Access Compliance Report

Public Rights-of-Way

(Curb Ramps)

Intersection ID: 50998	Main Street: S_TRYON_ST	Cross Street: STELECROFT_PY	Location: NE
ADA ID: 4A35C478A34C	Ramp Type: Perp	Initial Pass/Fail: Fail	Overall Compliance: No
Severity Score: 22.5			
Codes/Mitigation Info/Possible Solution		Field Measurements/Component Compliance

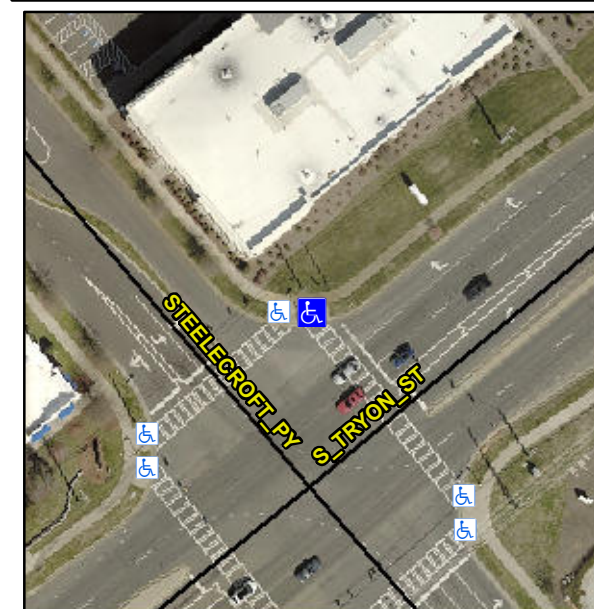
R304.5.1, R304.2.2, R304.5.3

Compliance	Description	Data	Compliance	Description	Data
N/A	Ramp Length (in)	95.0	No	Ramp Slope (%)	9.9
No	Ramp Width (in)	46.5	No	Ramp XSlope (%)	3.6
N/A	Flare Type LT	N/A	N/A	Flare Type RT	N/A
N/A	Flare Slope LT (%)	N/A	N/A	Flare Slope RT (%)	N/A
N/A	Flare Traversable LT?	N/A	N/A	Flare Traversable RT?	N/A
N/A	Landing Length (in)	N/A	N/A	DWS Provided?	N/A
N/A	Landing Width (in)	N/A	N/A	DWS Contrast?	N/A
N/A	Landing Slope (%)	N/A	N/A	DWS Length (in)	N/A
N/A	Landing X Slope (%)	N/A	N/A	DWS Full Width?	N/A
N/A	Landing Curb? (Y/N)	N/A	N/A	DWS Offset (in)	N/A
N/A	Shared Landing?	N/A			
N/A	Gutter Ponding?	N/A	N/A	Gutter Slope (%)	N/A
N/A	Gutter Lip Ht (in)	N/A	N/A	Gutter X Slope (%)	N/A
N/A	Painted X Walk1?	Yes	N/A	Painted X Walk2?	N/A
	X Walk 1 Direction	To SE		X Walk 2 Direction	N/A
N/A	X Walk 1 Width (in)	111.0	N/A	X Walk 2 Width (in)	N/A
	X Walk 1 Slope (%)	1.6		X Walk 2 Slope (%)	N/A
	X Walk 1 X Slope (%)	1.5		X Walk 2 X Slope (%)	N/A

Remove & Replace Entire Ramp.
